TENTATIVE
FINAL FINDINGS, CONCLUSIONS AND DECISION OF THE
HISTORIC LANDMARKS COMMISSION
ON AN
APPEALED ADMINISTRATIVE DECISION
(TYPE II PROCEDURE)

Case File Number: LU 20-198076 HR – New Solar Array

BARBEAU RESIDENCE

PROJECT DESCRIPTION
9.12 kW SOLAR PV PROJECT

SITE PLAN

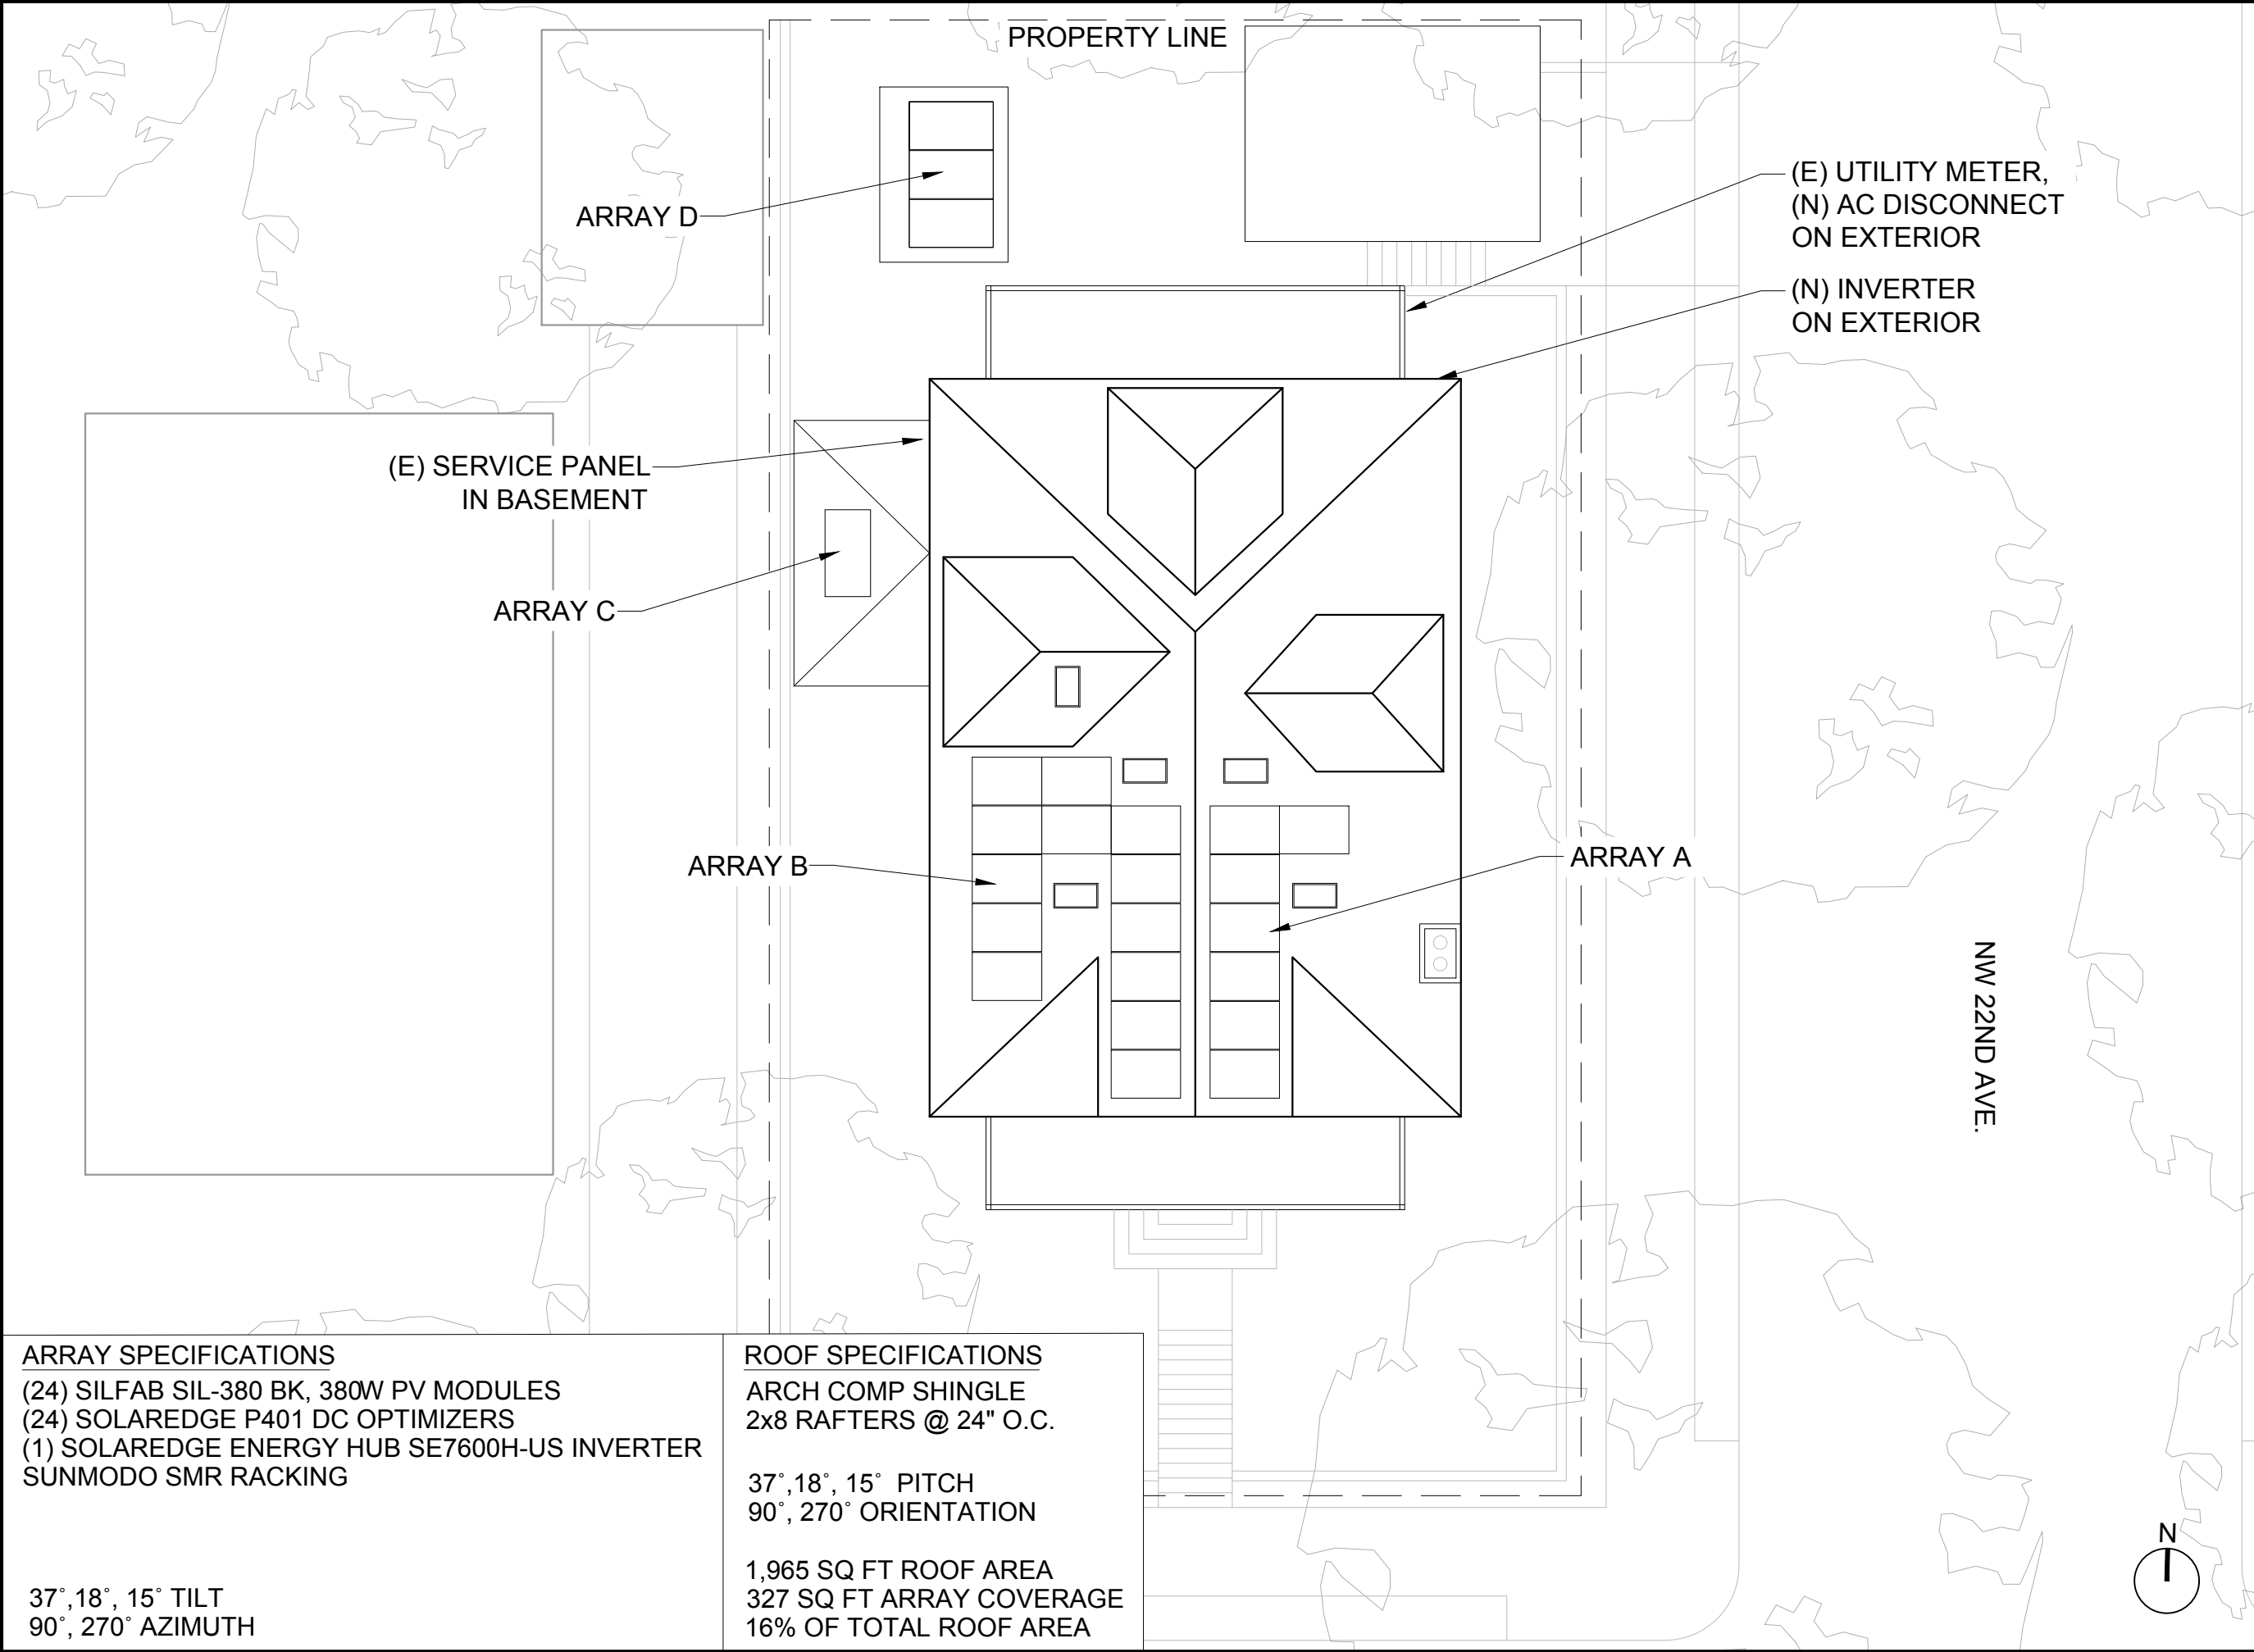
– will be located on the east (side) elevation adjacent to existing meters and will therefore be attached to existing historic siding; however, the attachment points will be minimal. The proposed solar array is shown to be located on the east and west slopes of the primary roof, as well as one panel on a lower projecting bay, and three panels on a small rear yard shed. The proposed panels are low profile, to be set at no more than 6" above the roof slope and are black in color. While not indicated on the drawings, the applicant's solar contractor indicated that the panels would be set at least 15" back from the front edge of the roof (see Exhibit A-18). The proposal also appears to meet or be substantially closer to meeting Fire Bureau requirements for escape pathways. Staff notes that the prior proposal showed panels set almost immediately at the roof edge and had conflicting notes about the panel height.

At the February 22, 2021 hearing, the Commission agreed with the applicant/appellant that due to the substantial height of the building, the proposed solar array on both slopes of the primary roof will be minimally visible as long as they are mounted low to roof and set back from the eaves. As noted above, the revised proposal indicates black panels, the face of which will be offset from the roof slope by 6", with the array set back 15" from the southern edge of the roof.

- D. The solar array shall be set with the top surface of the panels no more than 6” above the roof slope.
- E. The solar array shall be located at least 15” away from the southern edge of the primary roof.
